City Of Joondalup

POLICY 3.1.9 - HEIGHT AND SCALE OF BUILDINGS WITHIN A RESIDENTIAL AREA

SCHEDULE OF SUBMISSIONS FOLLOWING ADVERTISING REVIEW OF POLICY 3.1.9 (CLOSED 30/12/99)

BUILDING THRESHOLD ENVELOPE

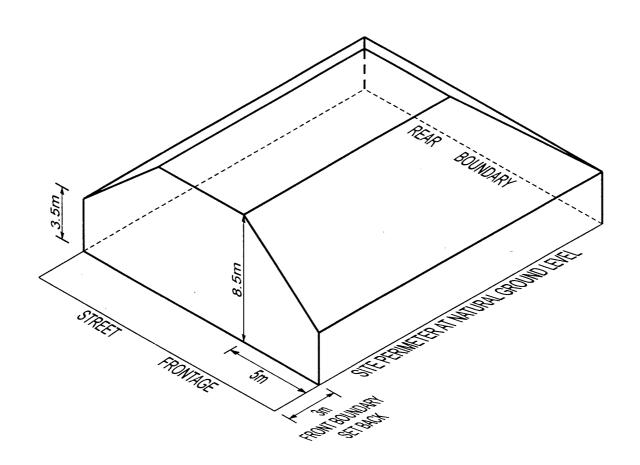
NO	NAME & ADDRESS OF SUBMITTOR	SUBMISSION SUMMARY	COMMENT AND RECOMMENDATION
1	State Manager The Royal Australian Institute of Architects WA Chapter	The definition of "Building Threshold Envelope" is difficult to comprehend. The words	It is considered that the terminology is equivalent in terms of the description offered.
QV1 Upper Plaza Level 250 St George's Terrace PERTH WA 6000	QV1 Upper Plaza Level 250 St George's Terrace	"increasing in line (metre for metre)" seem to be a complicated way for saying "increasing at 45 degrees".	No change to policy
		The second sentence of paragraph 1 in the Policy Statement is a denial of natural justice.	That the words "or complicated design" be deleted from paragraph 1 of the policy.
2	Director Hindley & Associates Pty Ltd Building Designers PO Box 199 NEDLANDS WA 6909	Complying applications should proceed straight to Building Licence without a requirement for development approval. Onus on applicant to prove compliance.	Applications for development approval and for building licences for developments, which do not exceed the building threshold envelope, are deemed to comply with the objectives of the policy and are processed by Approval Services in the normal manner. No change to policy.
